Team London Bridge response to the TfL Tooley Street Healthy Streets proposal, Jan 2019

Fig 3. Suggested measures a) to improve Duke Street Hill junction for walking and cycling

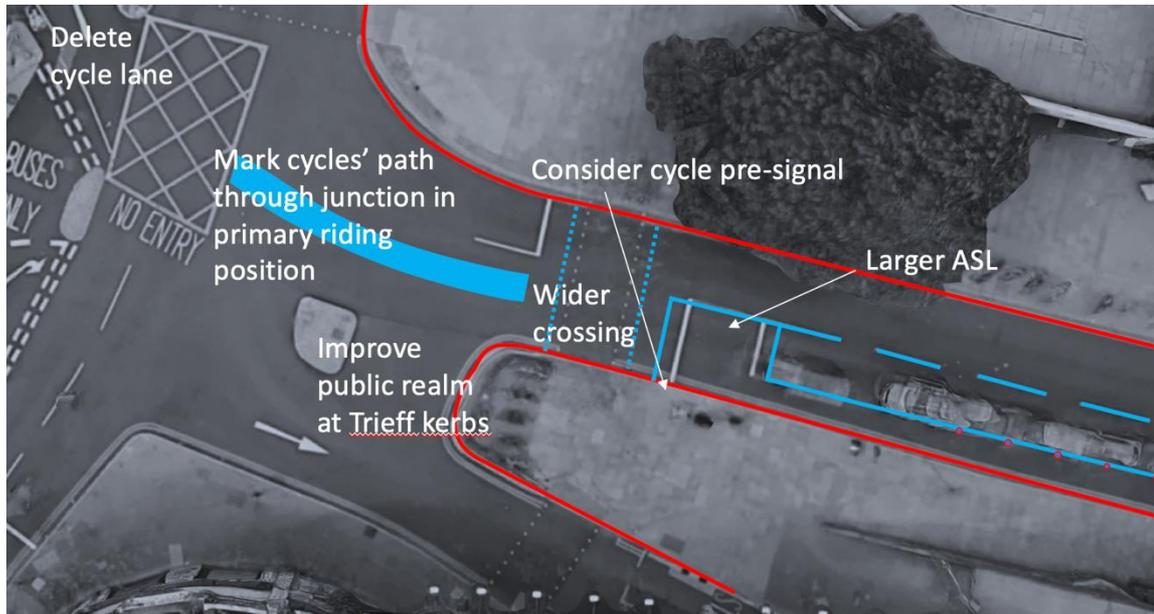
19. The proposed nearside cycle lane still leads cyclists into a conflict zone and therefore the issue of conflicts within the junction will remain. We would like to see this situation addressed. Potential solutions are suggested and illustrated below:

- a. Retain an ASL but make it deeper to accommodate rising flows of cyclists and provide cyclists with a head start. This could be complemented with a cycle pre-signal to enable cyclists to clear the ASL (although the conflict will remain for cyclists arriving after the pre-signal) and promote the primary riding position. We strongly suggest widening the pedestrian crossing, which is significantly over capacity at peak times (this will need proper assessment with the redevelopment of Colechurch House, and potential loss of London Bridge Walk, the pedestrian overpass)

Fig 4. Suggested measures b) to improve Duke Street Hill junction for walking and cycling

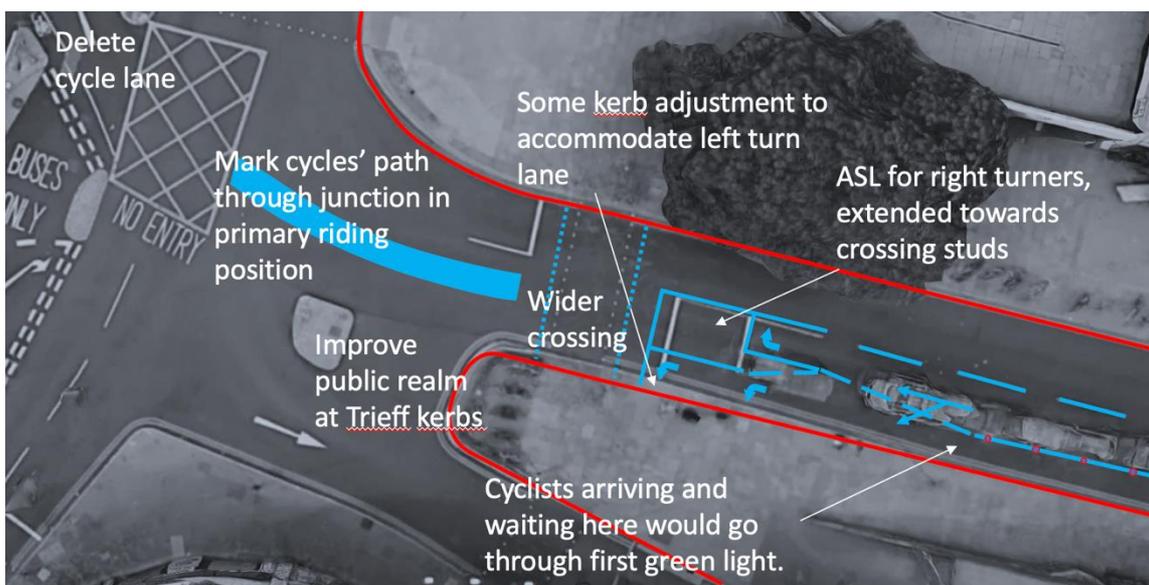
- b. Stopping the cycle lane about 20m from the junction, halving the ASL and splitting traffic flows into a left-turn and right turn lane. Consider a central right turn lane for cyclists leading into a deep half-width right turn ASL. Design the arrangement so that cyclists arriving at the end of the cycle lane get a guaranteed green due to the available green time and the length of the merge and can merge effectively into the stream of moving traffic. We have illustrated some initial options to consider in the sketches below.
